EDINBURGH TRAM YORK PLACE TO NEWHAVEN

DETAILED DESIGN

STAGE 2 Road Safety Audit – DESIGNERS RESPONSE

April 2021

Figure 4 - Ocean Terminal Bus Facility Swept Path

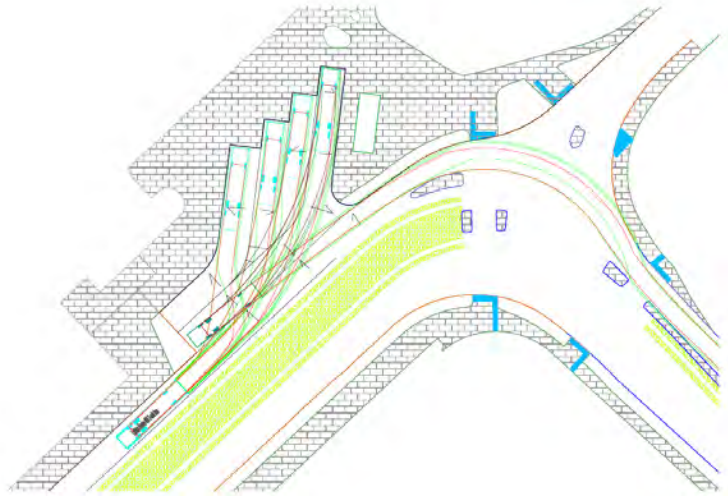
Swept path drawings have not been provided to the Audit Team. From the plans provided, it is unclear whether there is sufficient space for a vehicle to safely manoeuvre in this area without entering the carriageway or undertaking an unsafe manoeuvre.

The swept path analysis undertaken for the Ocean Terminal Bus facility indicates sufficient width to allow vehicles to access and egress the Ocean Terminal bus facility. See Figure 4

Figure 6 - Forth Ports Drop-Off Area Contours

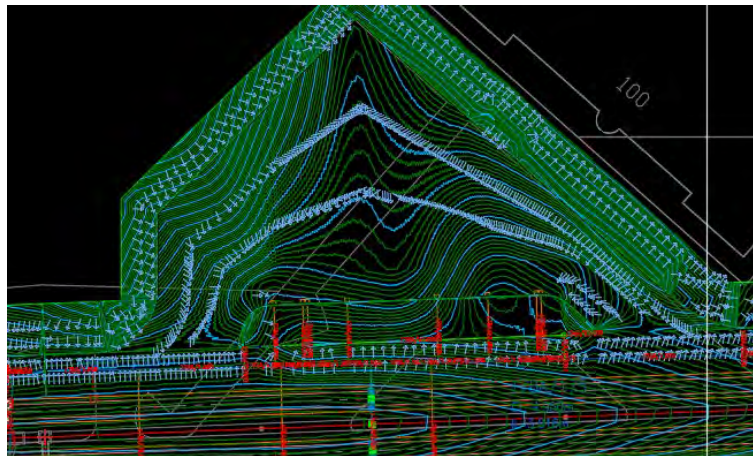
From the plans provided it is not clear if the existing drainage at the Cruise Terminal Drop-off point is being changed. The Audit Team have concerns that surface water may pool at interface between the new surface and existing drainage lines at the location shown above.

The observed photograph included in the stage 2 road safety audit report is a picture off the existing Forth Ports drop off layout and not the proposed works.

However the existing layout of the Forth Ports drop off is to be altered such that the hardstanding area will drain from the building towards Melrose Drive Figure 6. New gullies are located on the hardstanding side of the shared footway/cycleway providing a positive drainage connection to the new carrier drain in Melrose Drive.

Figure 11 - Lindsay Road Pedestrian Crossing

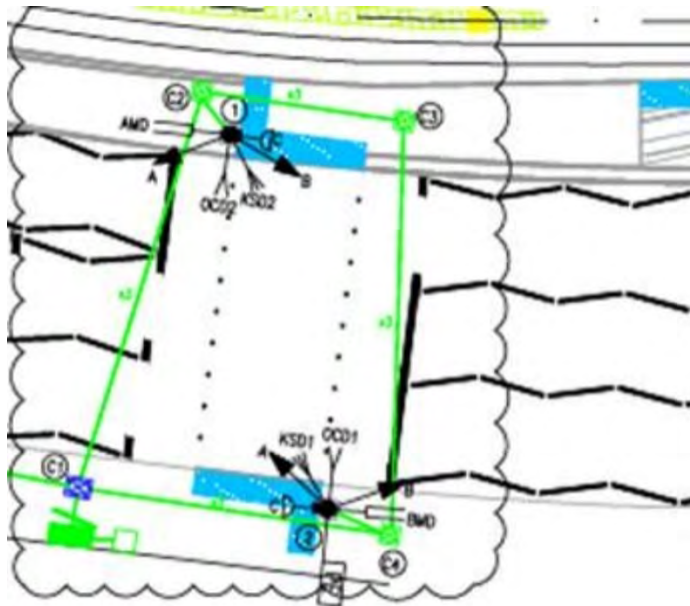
From the plans provided, it appears that no secondary traffic signals are proposed at the signalised pedestrian crossing on Lindsay Road. With two lanes of traffic approaching the signals, there is a possibility that the primary signal head and / or duplicate primary could be obscured by large vehicles. There is also a risk that a signal head could fail, meaning that approaching drivers / riders may not be able to see a signal head on approach to the crossing.

Secondary signals have been added to the design. See Figure 11

Figure 12 - Leith Sands Landscaping

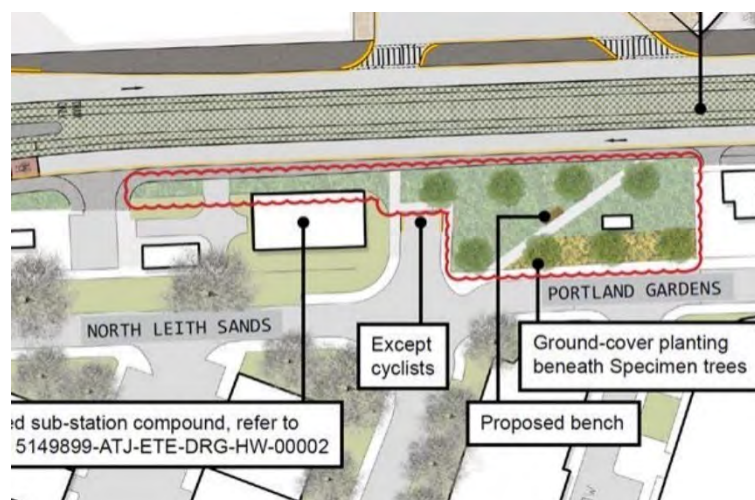
There are existing sections of footway on the south side of Melrose Drive. The proposals show a new 2.5-metre-wide footway on the south side of the road, offset from the existing kerb line. From the plans provided to the Audit Team, it is unclear if the existing sections of footway are to be retained.

The existing footway is to be removed and landscaped as indicated in Figure 12

Figure 13 - Swept Path Leith Sands Substation

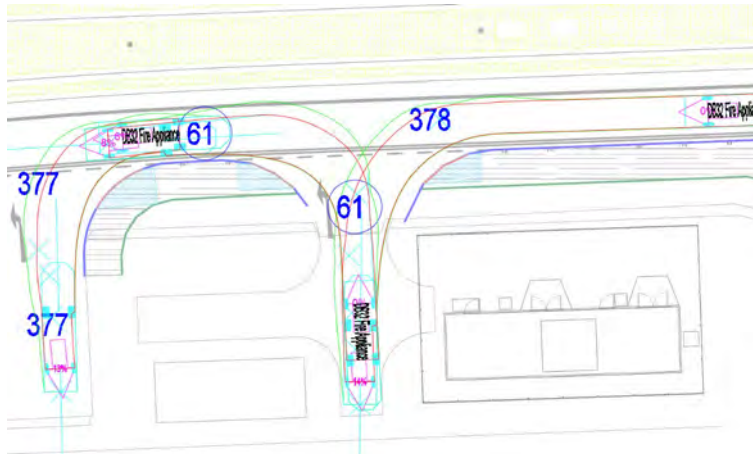
An uncontrolled crossing is currently provided across the access to the Leith Sands Substation. From the plans provided to the Audit Team, it appears that the existing arrangement at this location is to be formalised by providing a new section of footway, tactile paving, and a dropped kerb around the full extent of the new footway.

The vehicle tracking drawings that were provided to the Audit Team show a DB32 Fire Appliance overrunning the new area of footway when making a left turn into the access.

The swept path analysis provided clearly indicate adequate available road width at the entrance to accommodate the design vehicle

Figure 21 - Ocean Drive Road Markings

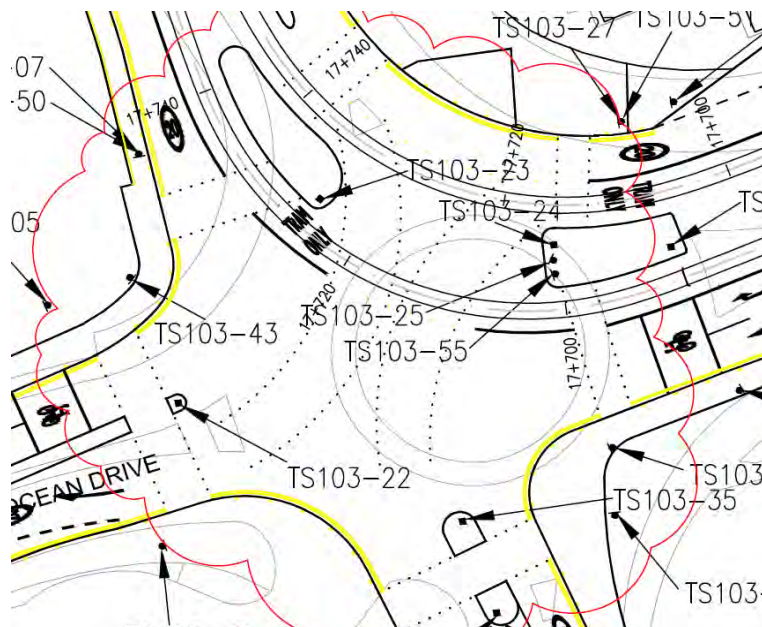
The drivers / riders of vehicles turning onto Ocean Drive, particularly those from Victoria Quay, could inadvertently enter the tram lane and make a lane change upon realising that they are in the wrong lane, leading to side-swipe collisions occurring with vehicles in the nearside lane.

The provision of road markings through the junction will assist to guide vehicles from Victoria Quay into the correct lane. 'Tram Only' road markings have also been provided to make drivers aware of the lane arrangement.
